ADDENDUM NO. 2

This addendum includes Item Number 2-1 thru 2-28. This addendum item shall be fully incorporated into the Bidding/Contract Documents and have the same force and effect as though originally included.

**Life Science Collaboration
 UNL Food Science and
 Technology**

1910 N Antelope Valley
 Parkway
 Lincoln, Nebraska
 TCEP No.: 716-006-13

A6.32

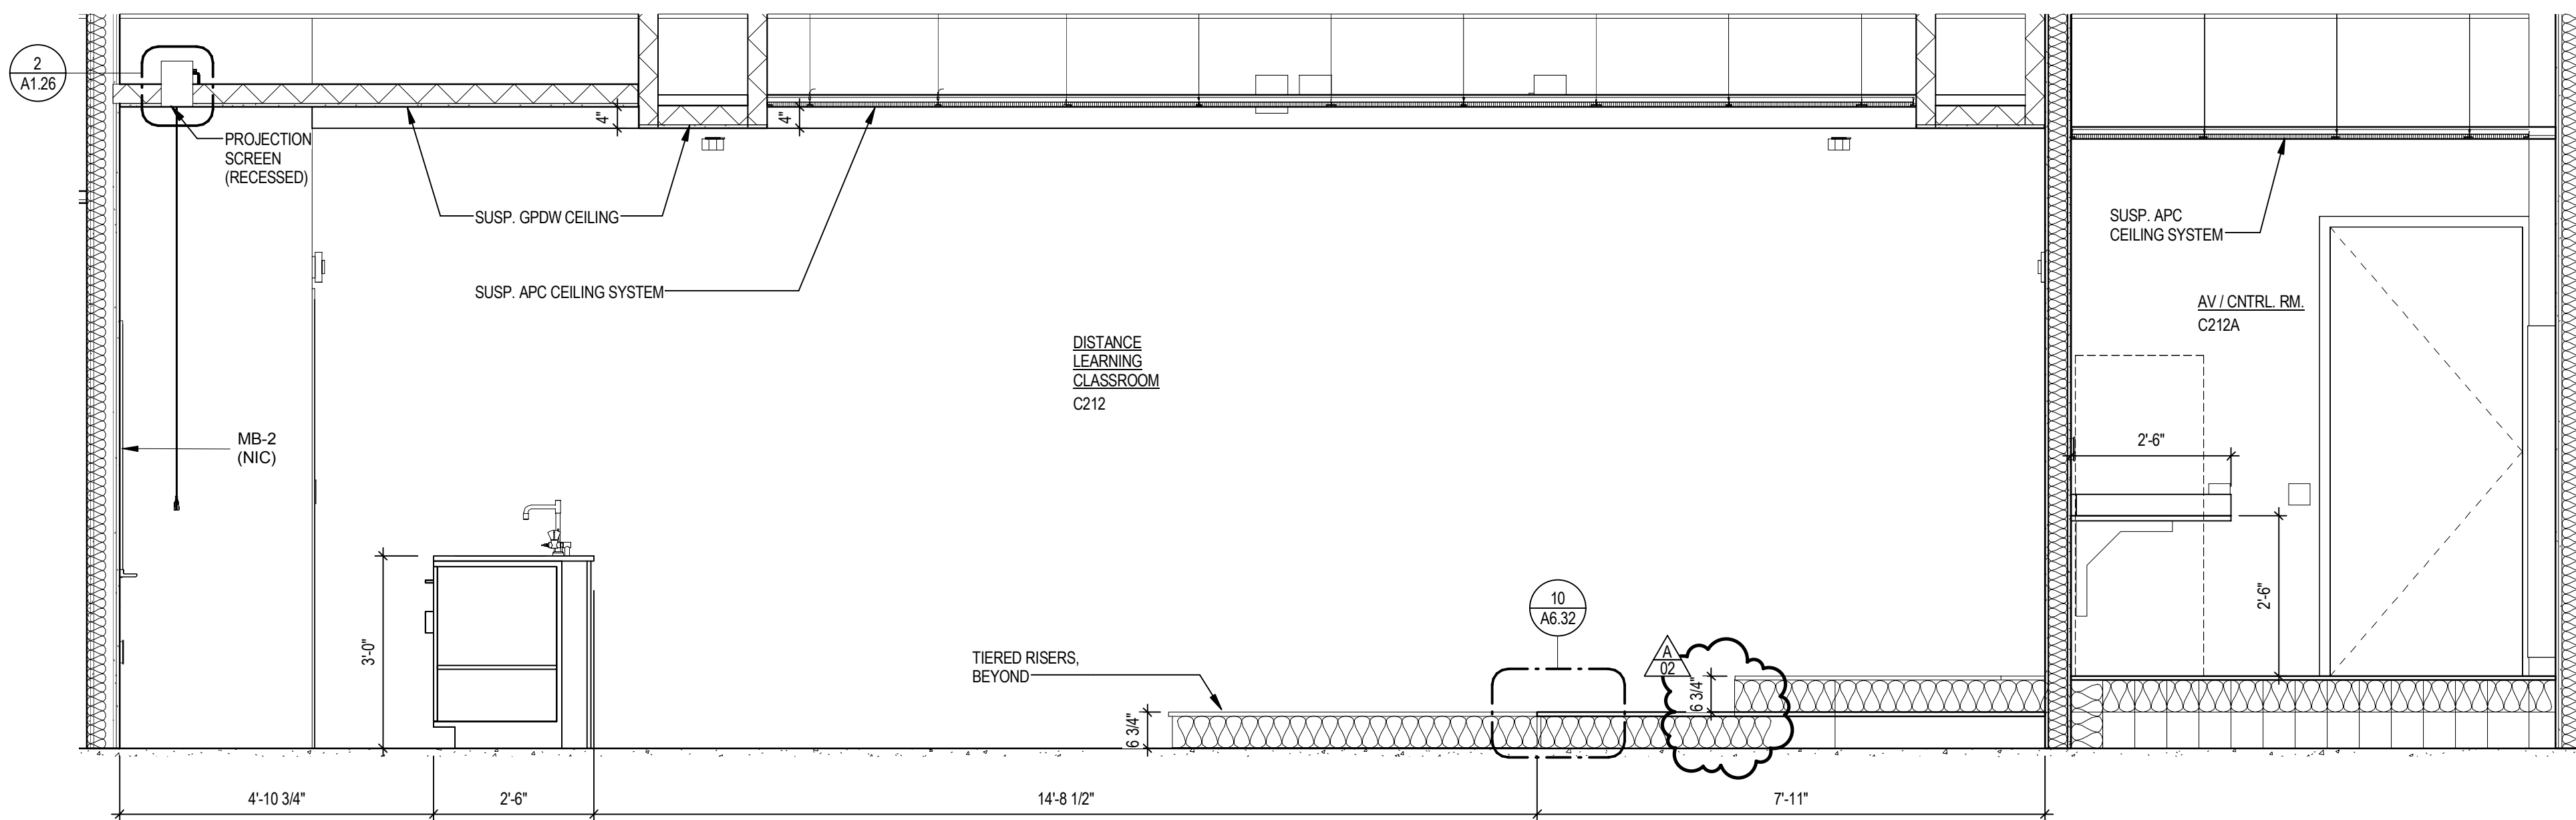
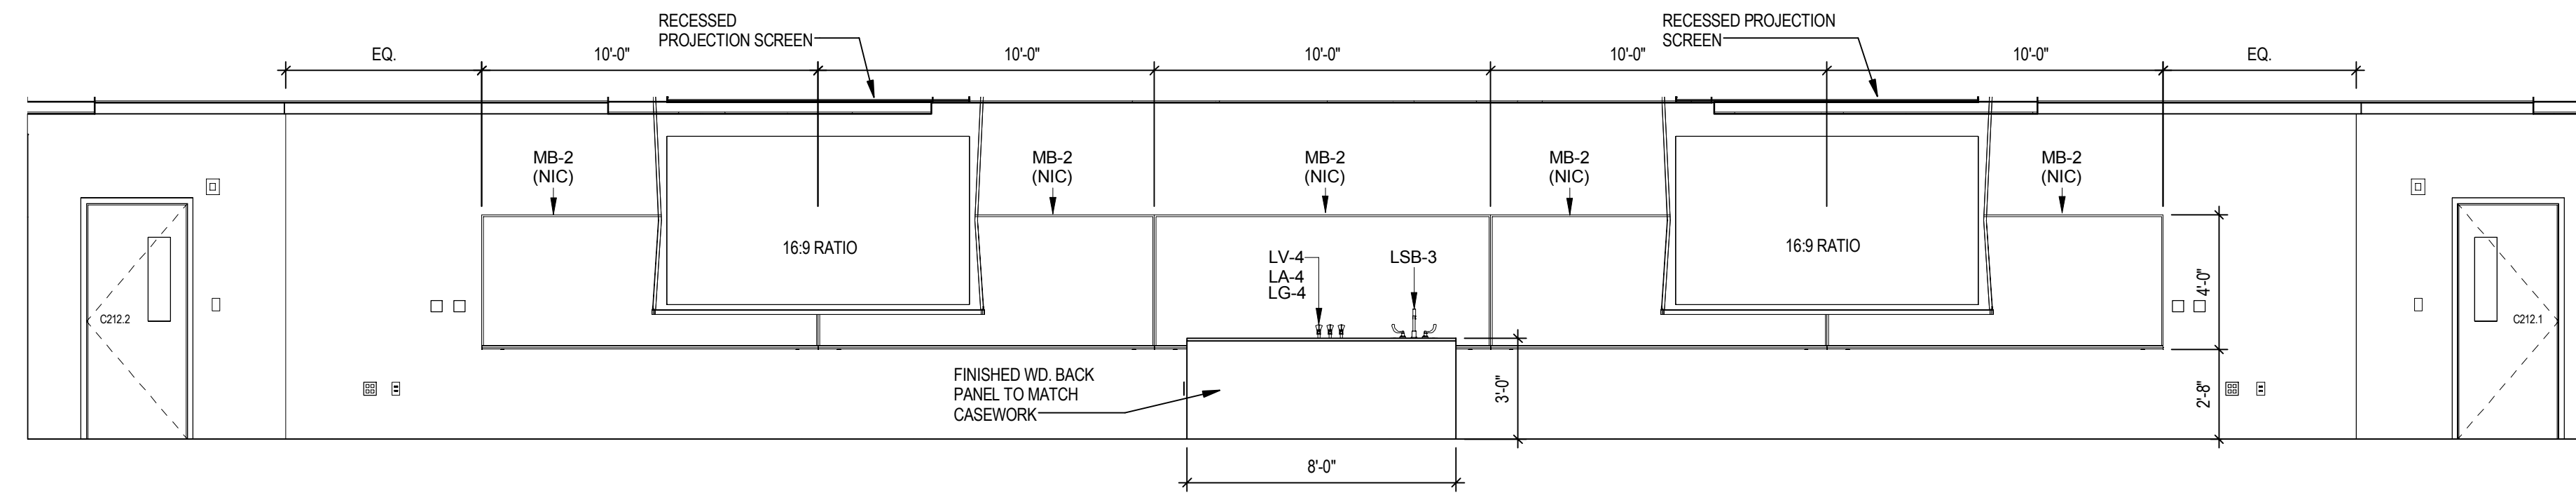
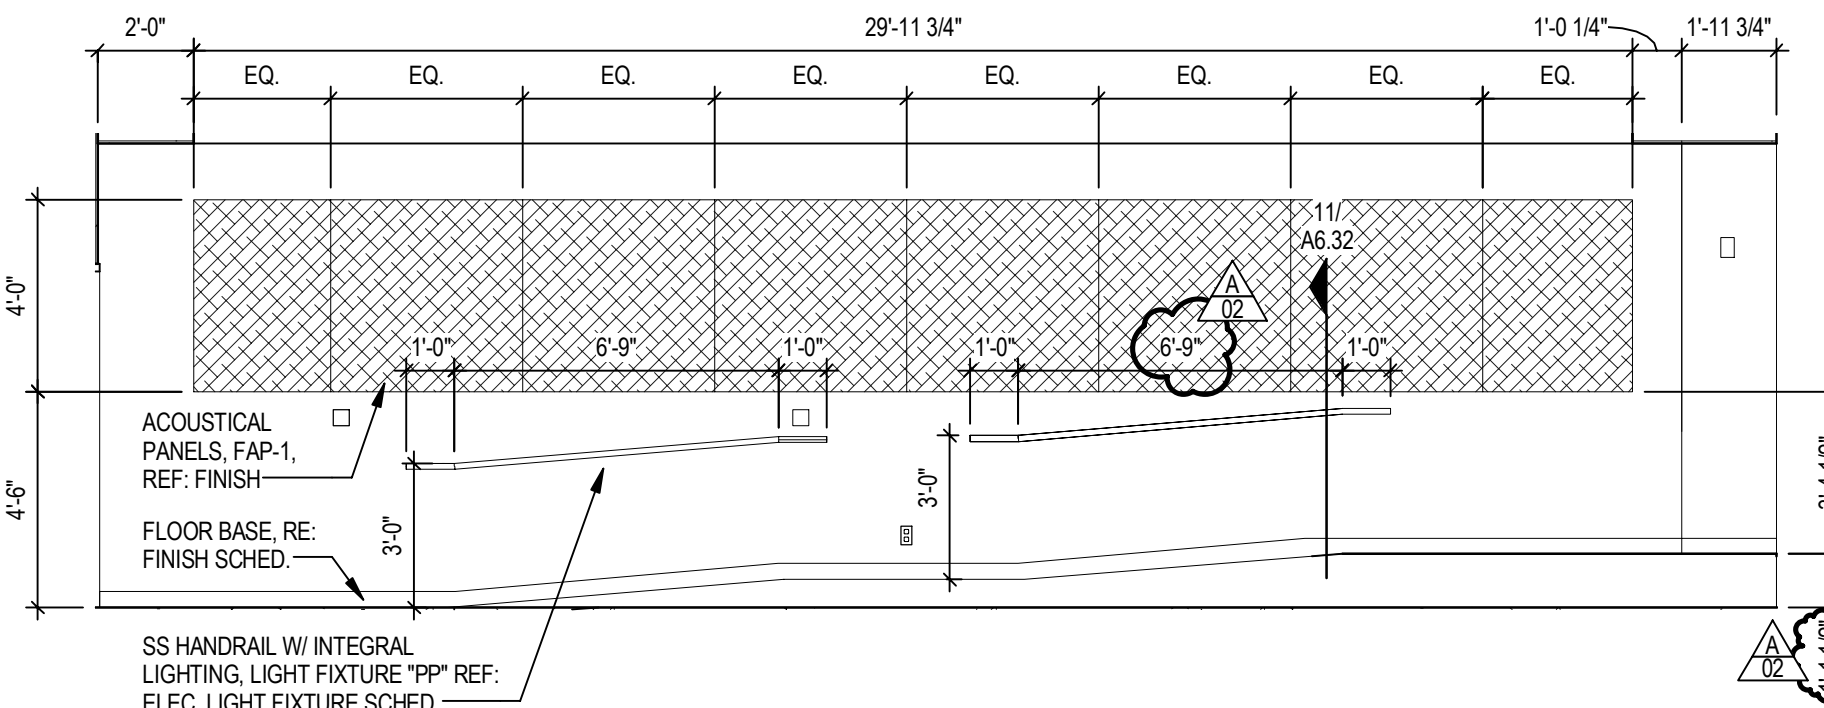
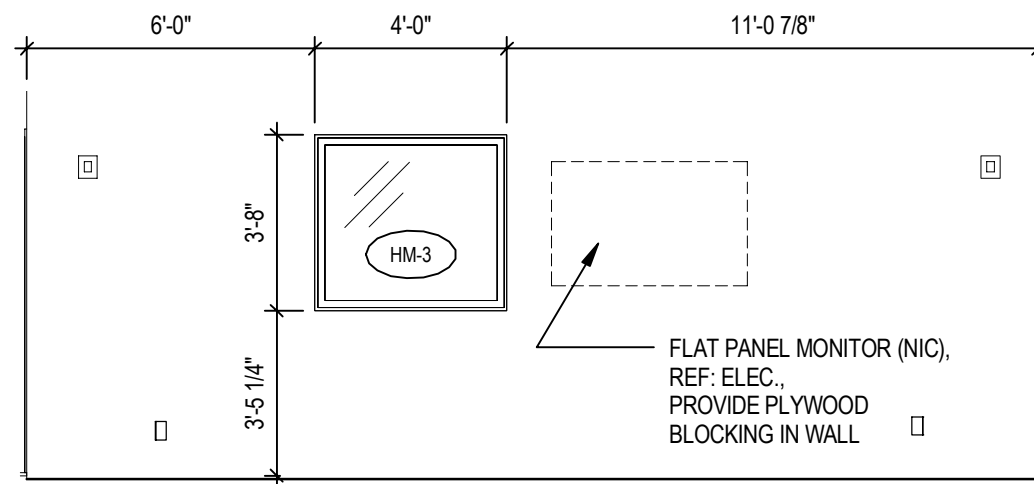
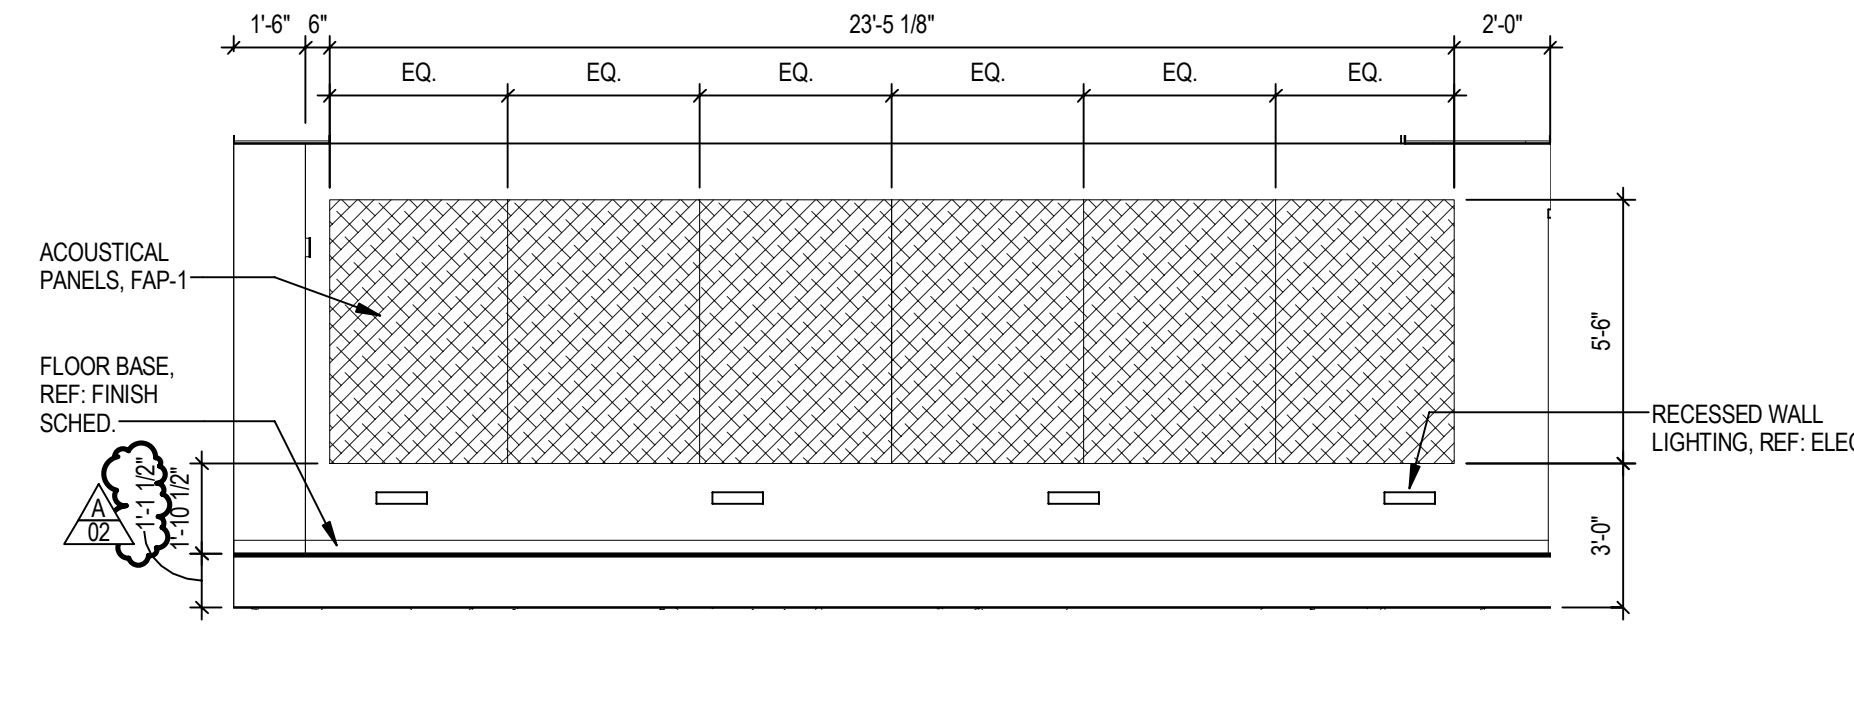
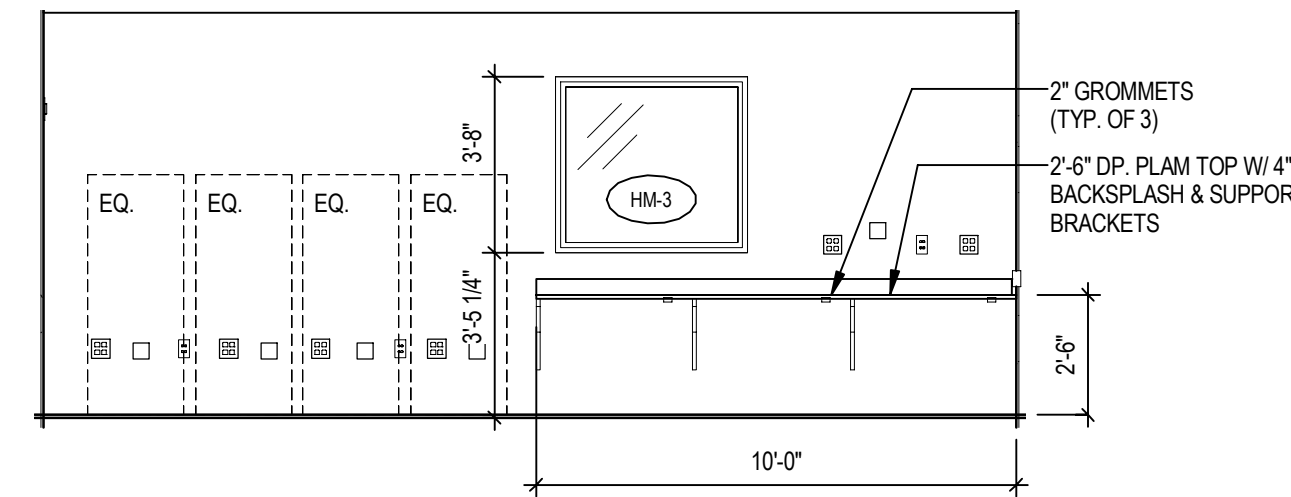
Item 2-15: A6.32 – Distance Learning Classroom Plan, Elevations, & Details

Refer to revised sheet for updated table dimensions, upper floor height, and updated details.

9 KITCHEN EXHAUST FAN

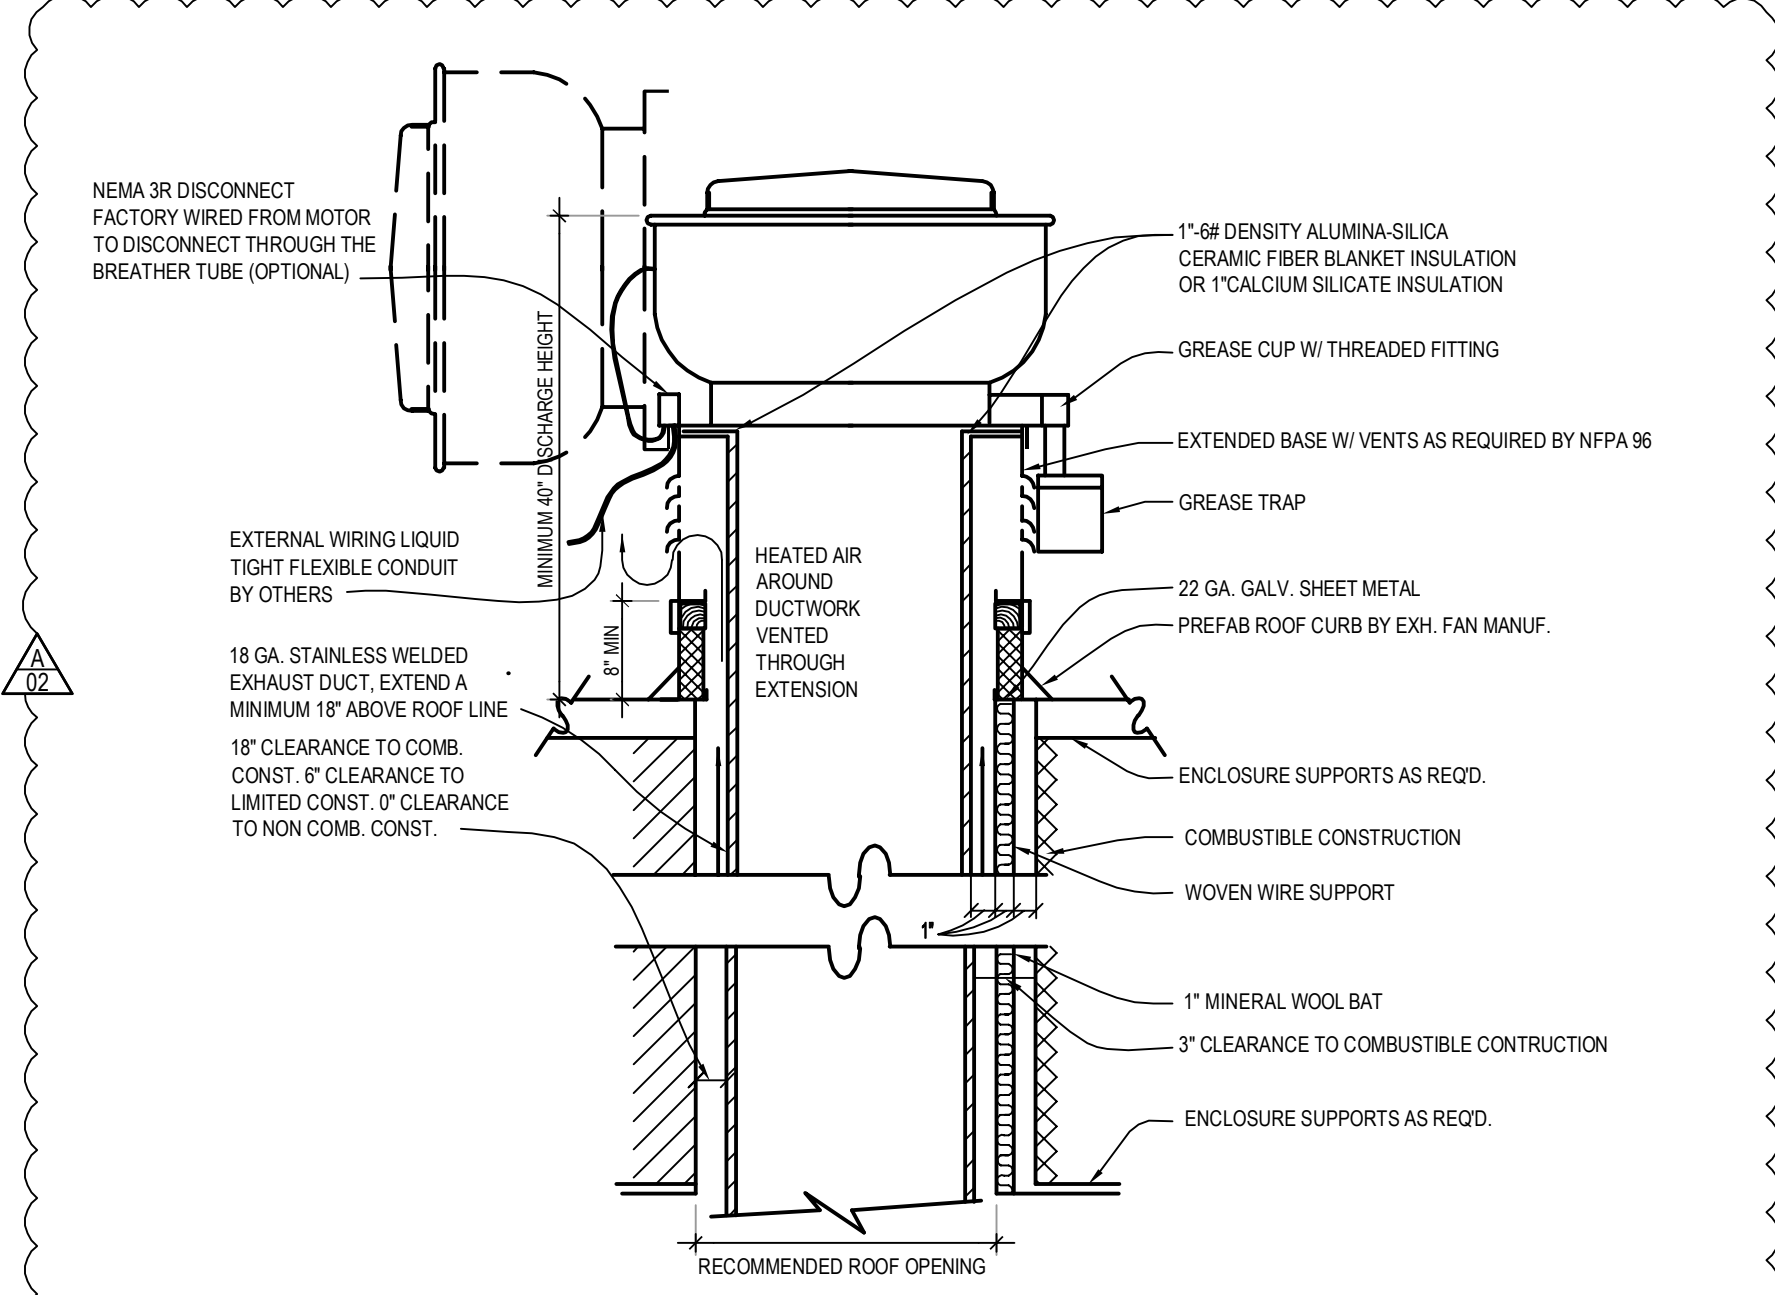
Item 2-19: M4.03 – Mechanical Details

Refer to revised sheet M4.04. See added detail 9 - Kitchen Exhaust Fan for installation information for grease duct termination/fans.
